MEMORANDUM

FILE NO.: SMF2011 0001

PROPOSAL: Final Plat for Vista Del Sol subdivision - a major subdivision of 24 lots (originally proposed as 25 lots)

PLAT OF
VISTA DEL SOL SUBDIVISION PHASE II
A SUBDIVISION OF
LOT 1, VISTA DEL SOL SUBDIVISION PHASE I
WITHIN U.S. SURVEY NO. 1568
CITY & BOROUGH OF JUNEAU, ALASKA
JUNEAU RECORDING DISTRICT

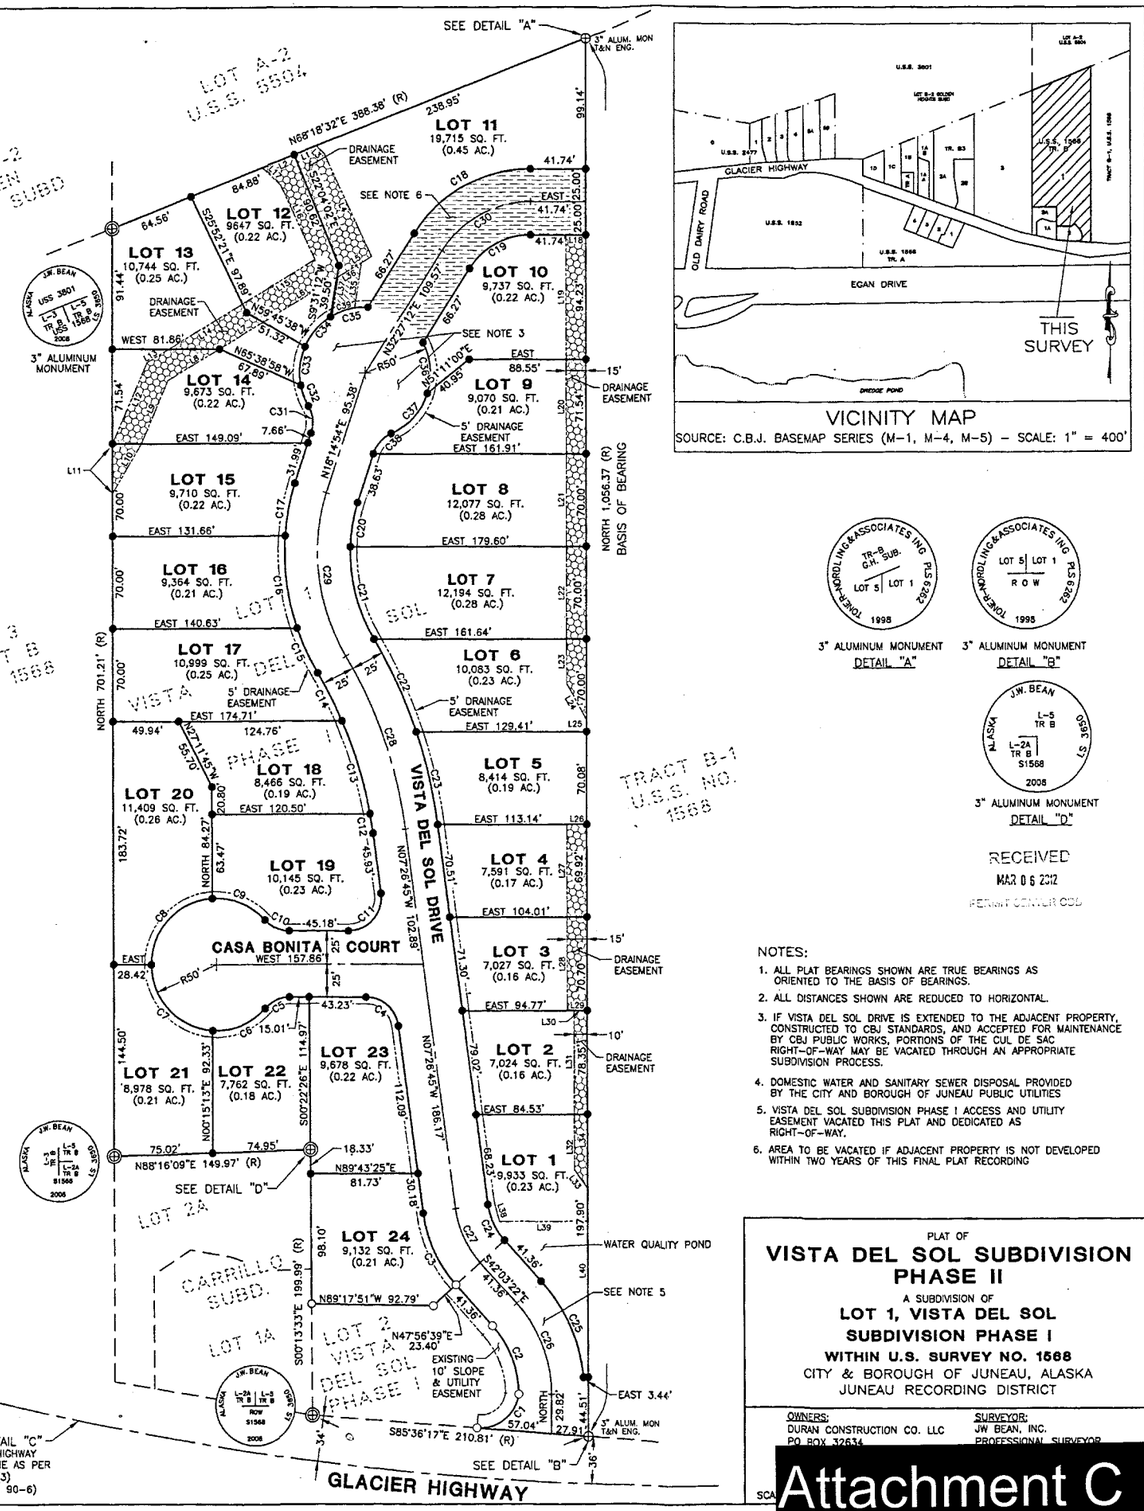
The applicant is requesting the waiver of construction of the roadway from the temporary cul-de-sac on Vista Del Sol Drive to the neighboring property per CBJ §49.35.240(c). Staff supports this request as it is the neighboring property owner's obligation to build that portion of the road in the event of development on the adjacent parcel.

A plat note cannot supersede a process outlined in the Land Use Code. While the applicant may petition in the future for this street vacation, a note on the plat cannot automatically vacate the street after a certain period of time. Staff recommends removal of this note as it is inconsistent with the Land Use Code.

It should be noted that this plat note was included on the preliminary plat that was approved in 2008; however, the revised plat that included this note was submitted approximately a week before the public hearing. The staff report that accompanied this version of the final plat does not address this note; in fact, the staff report discusses the requirement of the connection to the adjacent property and the importance of street connectivity. This preliminary plat was on the consent agenda and therefore this discrepancy with this issue was not discussed at the public hearing. Regardless of this, a plat note cannot supercede procedural requirements as codified in the Land Use Code. Staff recommends the removal of this note from the final plat before recording.

2. Note 6 must be removed from the final plat. The final plat will not be recorded until this note is removed from the plat.

3. Note 5 will be revised to state the following: ***Vista Del Sol Subdivision Phase I access and utility easement vacated Deed Book XXX, Page XX and dedicated as right-of-way this plat.***
